Supply and Demand Correlation

New Mexico – Gila Basin – Arizona Water Settlement Act

**U.S. Department of the Interior
Bureau of Reclamation
Phoenix Area Office**

Attachment A – Supply and Demand Correlation Comments/Responses

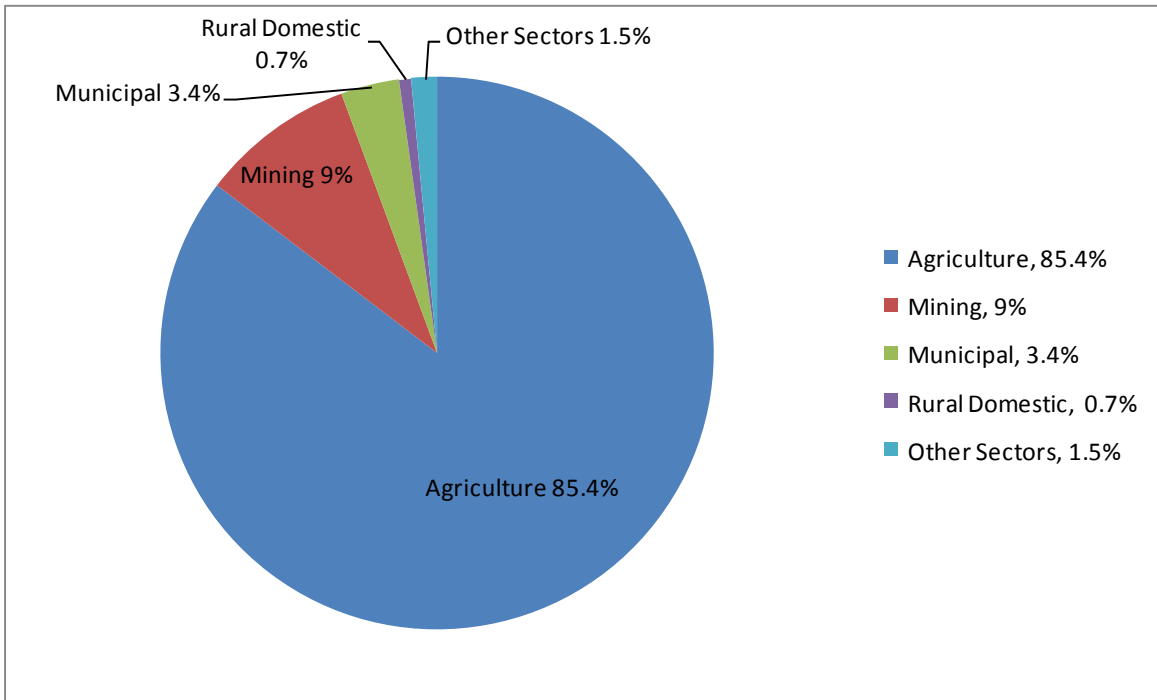
- 3. P9, section 2.1.2 through section 2.1.5: Comment:** This section apportions water demand by sectors. It would be useful to include a pie chart that allows relative proportions of demand by sector to be easily seen.

Response: A pie-chart has been added.

Figure 3.1. – Map of Southwest New Mexico Planning Area

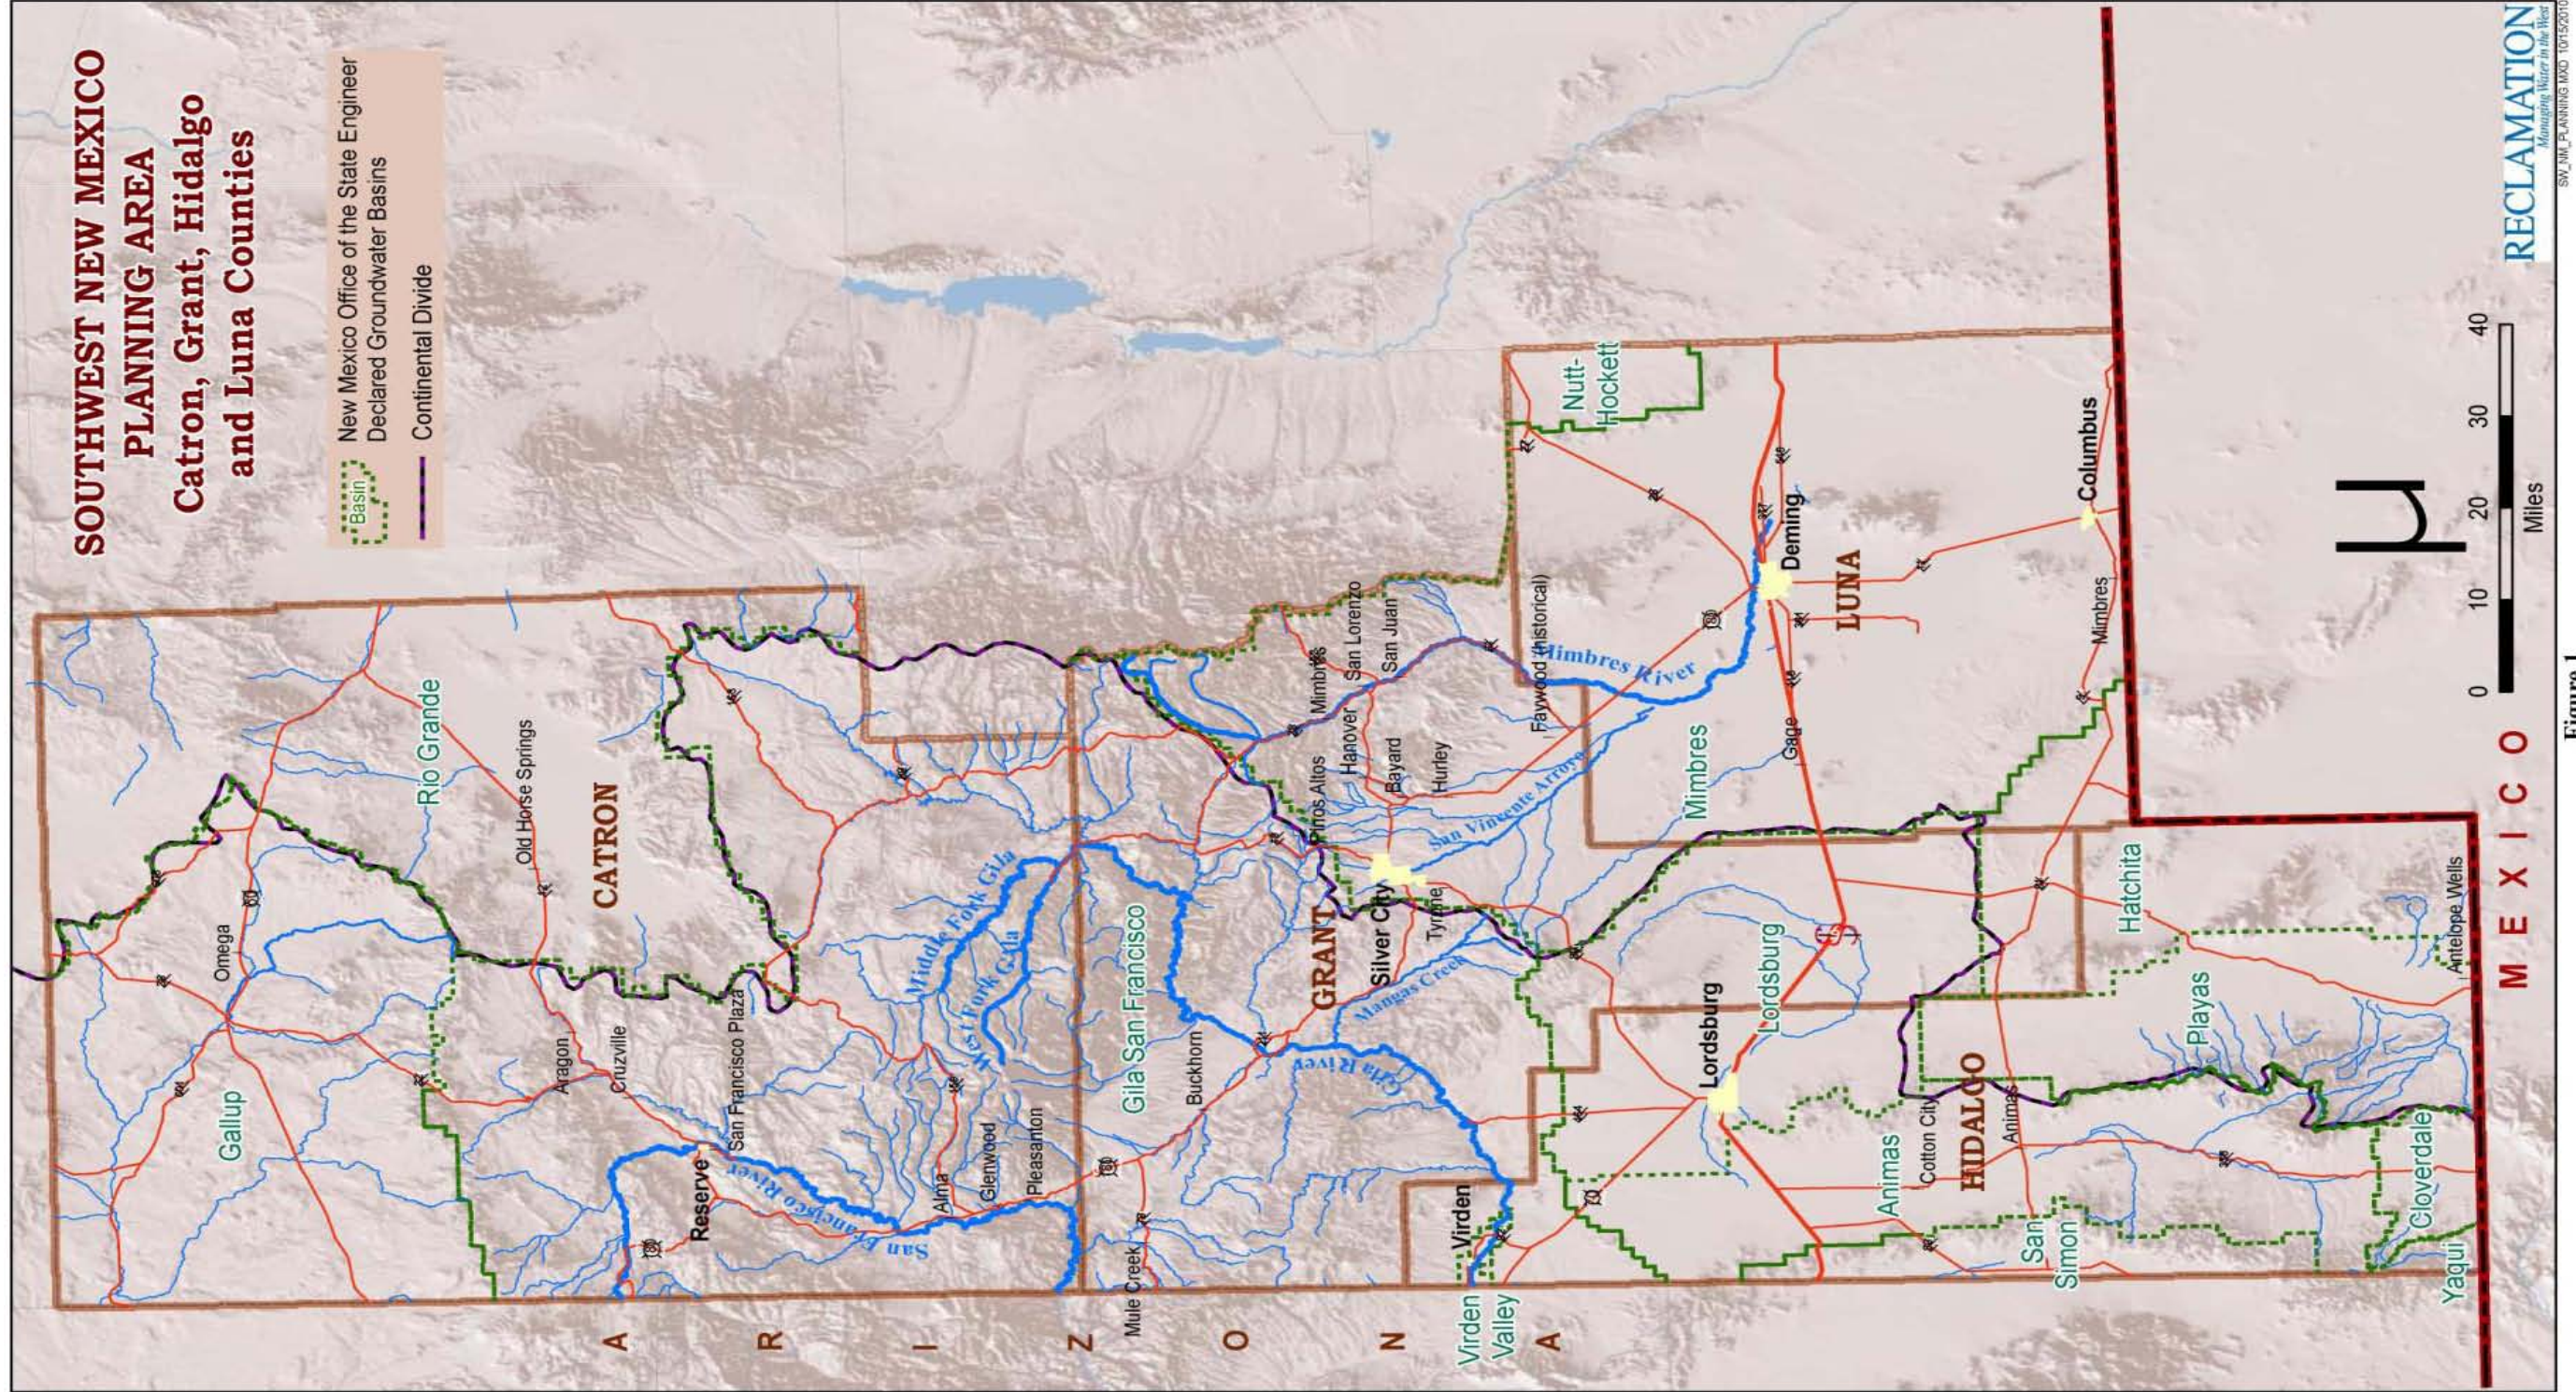
- 3. P4, section 1.2, par 4: *Comment:*** Does SSPA specify where or in different locations?

Response: SSPA did mention recent monitoring of alluvial observation wells installed along four transects across the Gila River (Figure 3.1) in the Gila-Cliff Valley. It is interpreted the statement refers to the four transects (FM-1, FM-2, Bird, and TNC transects; see Fig. 3.1) and intervening seepage investigation measurement areas (see Fig. 3.8) along the Gila River in their two Riparian models, in Reaches 1 and Reach 2. These two model areas occur between Mogollon Creek at Gila River to the north, and below Mangas Creek where it joins the Gila. They were able to characterize gains and losses in reaches between the USGS gage Gila River near Gila (09430500) and the Bird Area, which is located upstream of the Middle Box area.
